URBAN DESIGN COMMITTEE

AGENDA

URBAN DESIGN COMMITTEE STAFF REPORT

APPLICATION NUMBER	Urban Design Record #23126
APPLICATION TYPE	Advisory Review
ADDRESS/LOCATION	205 S 10 Street
HEARING DATE	December 05, 2023
ADDITIONAL MEETINGS	-
APPLICANT	Joy Skidmore, joy@theannexgrp.com
STAFF CONTACT	Arvind Gopalakrishnan, 402-441-6361, agopalakrishnan@lincoln.ne.gov

Material Palette

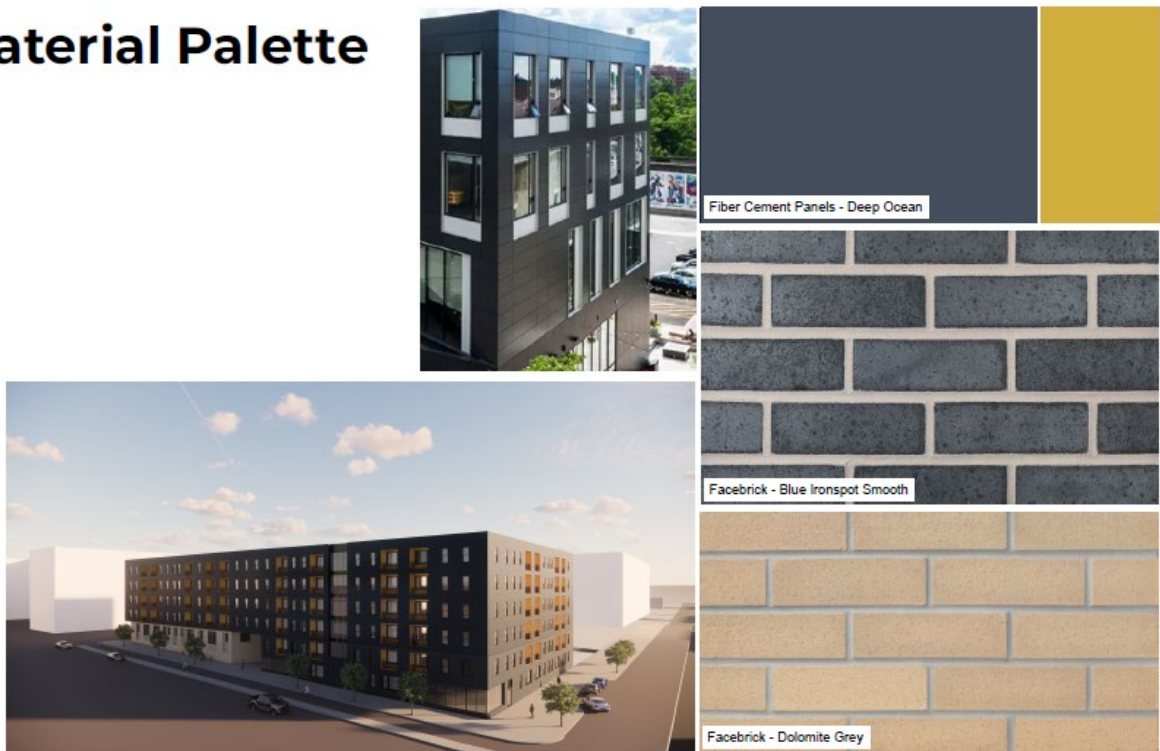
Materials:

- For the first 20 (twenty) feet above street level, durable masonry materials, such as stone, brick, or tile, or similar materials such as pre-cast concrete, or poured-in-place concrete are required as the primary exterior material facing streets for Downtown Lincoln buildings. Ample windows are allowed but glass curtain wall structures are allowed only in the area more than 20 feet above street level. Decorative accents of durable materials including metal architectural panels, architectural tile, and metalwork are allowed. Other high-quality, durable materials as accents or primary materials may be proposed to and approved by the appropriate design review board. - **Compliant**

The proposal displays the use of facebricks up to the third story from the sidewalk, fiber cement panels from the third story up to the top of the building.

Vehicular Drop-off, accessibility, and landscaping:

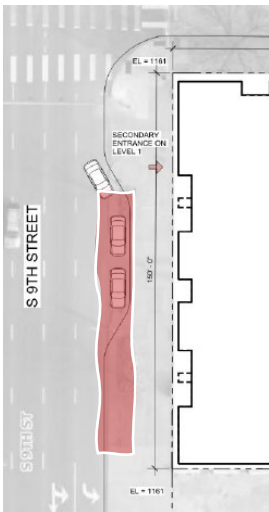
In the updated drawings, the proposal shows a preliminary vehicular drop-off area near the secondary entrance on level 1, on 9th Street. Staff recommends that the proposed area drop off area on 9th Street be extended southwards to the extent of the building and provide more space for loading and unloading. This detail will need to be addressed at a later date, along with streetscape design concepts.

Streetscape Design:

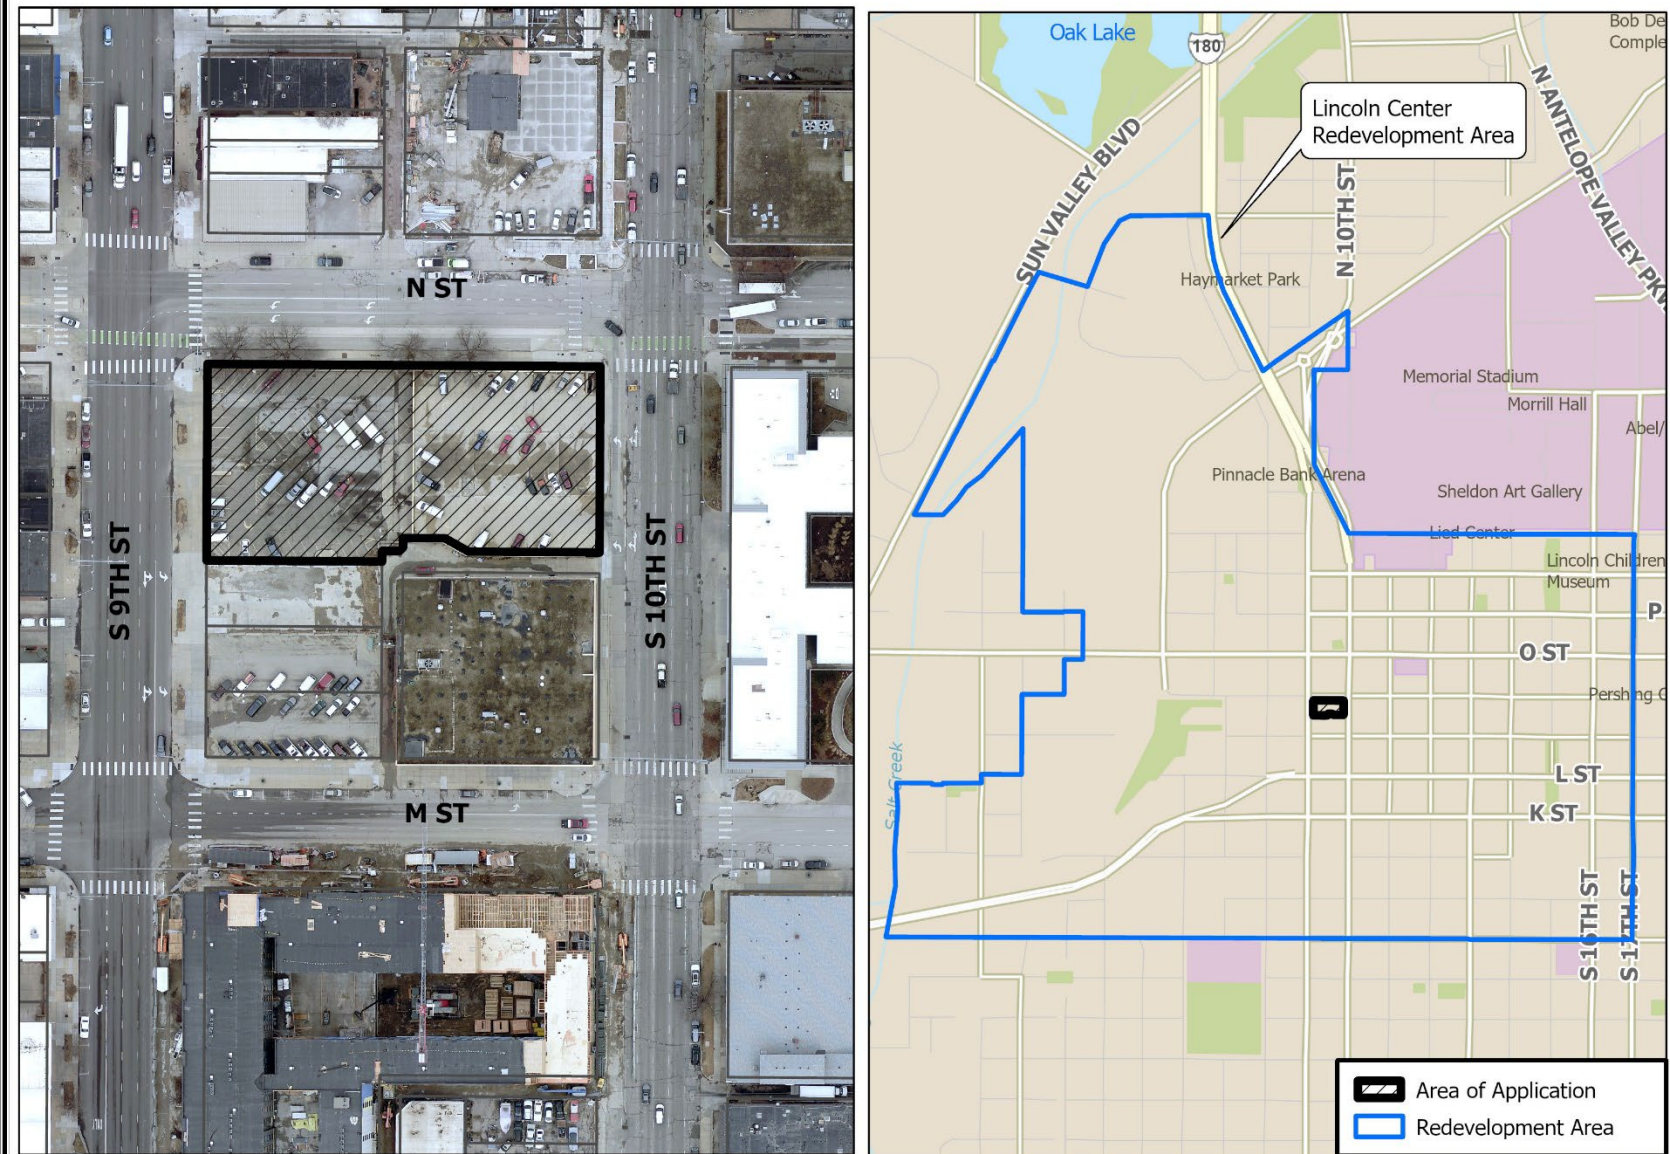
Landscaping and other streetscape design concepts will be presented at a later date, likely in early 2024. This will be a coordinated effort between the applicants and the concerned departments of the City to ensure that the proposed design aligns seamlessly with the City’s overarching goals for 9th and 10th Streets as part of the Downtown Corridors Project, emphasizing safe and efficient traffic movement for pedestrians, cyclists and vehicles, while creating a visually appealing urban environment.

ATTACHMENT B – Site Plan

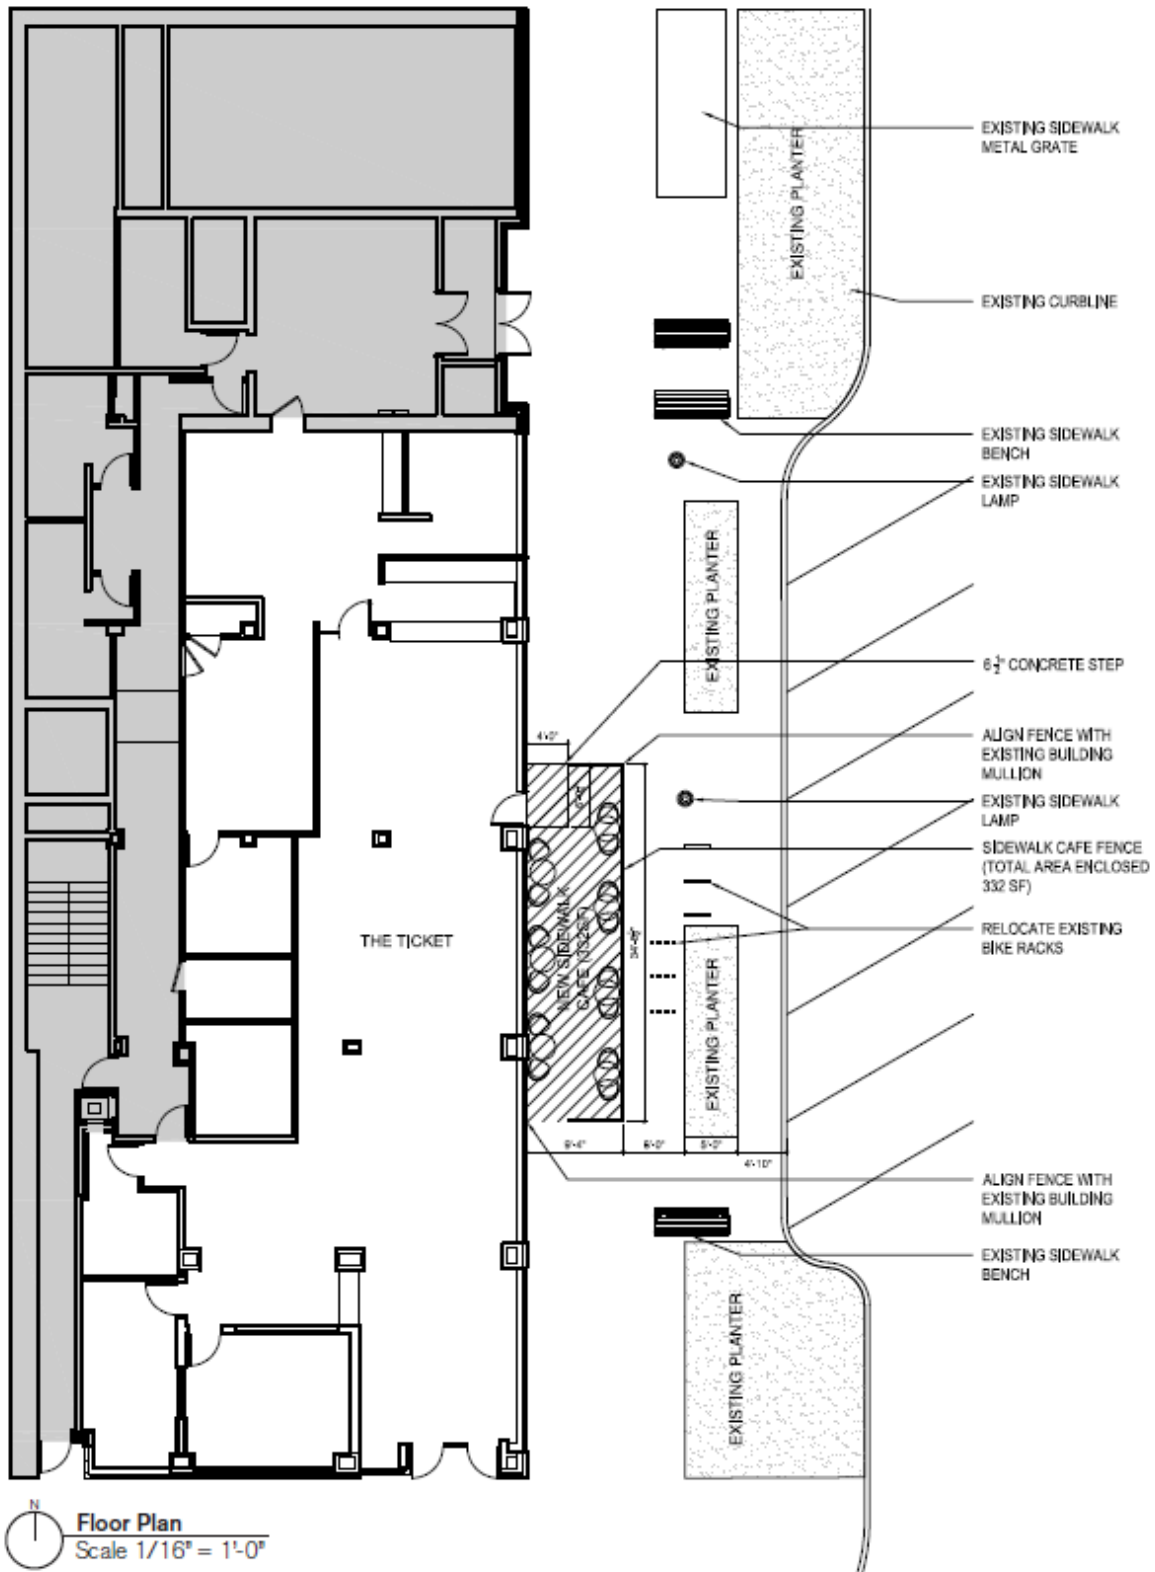
The fencing has been installed as per the drawings, and the bike racks have been uninstalled to make space for pedestrians. After the removal of the bike racks, the current sidewalk café width of 9’-4” would leave 6’ for pedestrian movement. The city will coordinate with the DLA to install the bike racks slightly east, aligned with the existing planter.

City staff also recommends that the metal bench just south of the café and the set of 2 benches north of the café (circled in the map above), be removed from its current position, and relocated about 3' to the east, aligned with the existing planters. This would help ensure a smooth flow of visitors to and from the sidewalk café and leave enough space for bike parking without interrupting the pedestrian flow on the sidewalk.

- *Capacity: 14 persons – compliant*
- *Currently, there are two 4' wide entrances to the sidewalk café. Since the café plans on serving alcohol, one of the entrances would have to be closed. The city staff has asked the applicant to close one of the openings with the same metal railing.*

The position of the trash receptacle is not included in the site plan, but the applicant has confirmed that it would be included in the café.

Recommendations

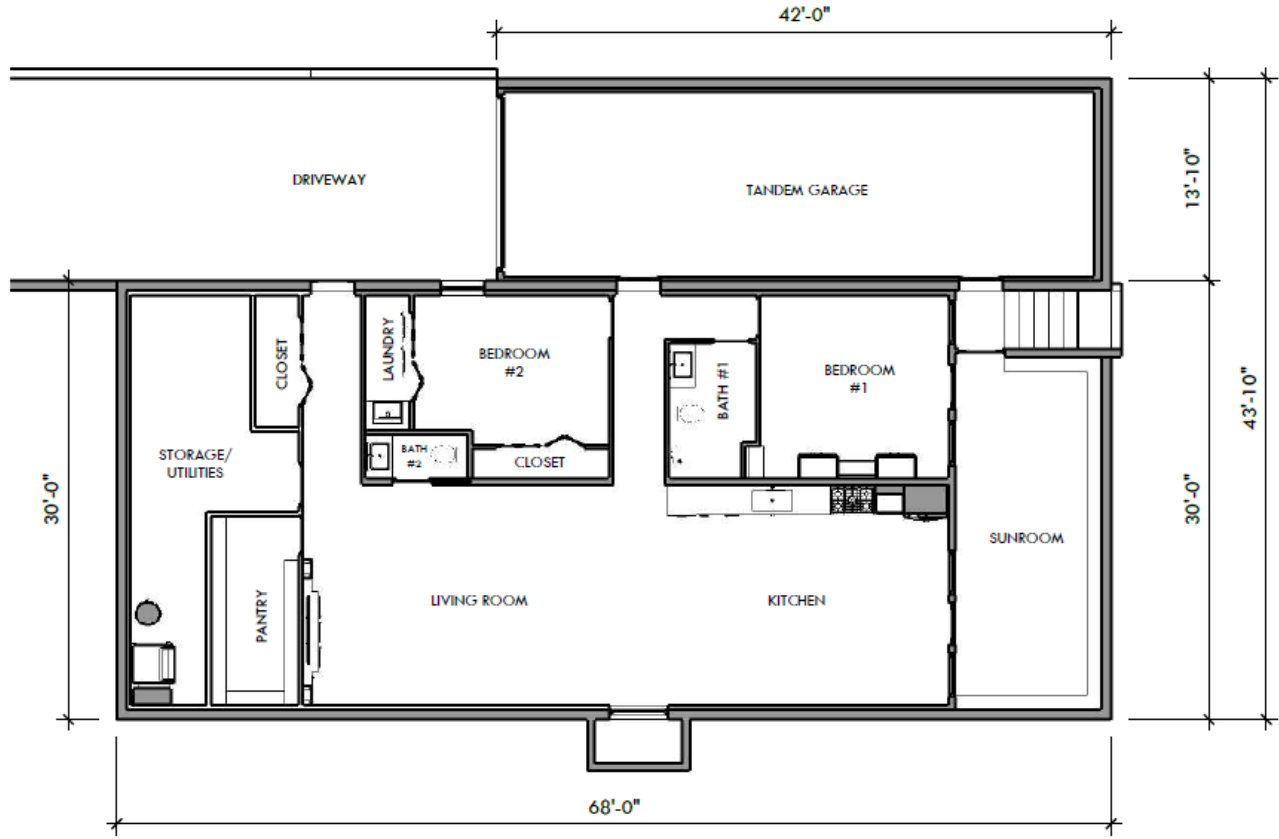
Given the nature of the project, the Planning Department recommends the garage have a white laminate or a frosted glass door instead of a fully opaque door. Although it would still not meet the window and opening requirements, at least some design intent or feature to accentuate the façade is advised.

Since this house design does not blend with the neighboring properties, we also recommend incorporating colorful and ornamental plants and shrubs around the garage for to improve the overall appearance of the property and foster a more cohesive architectural context within the community.
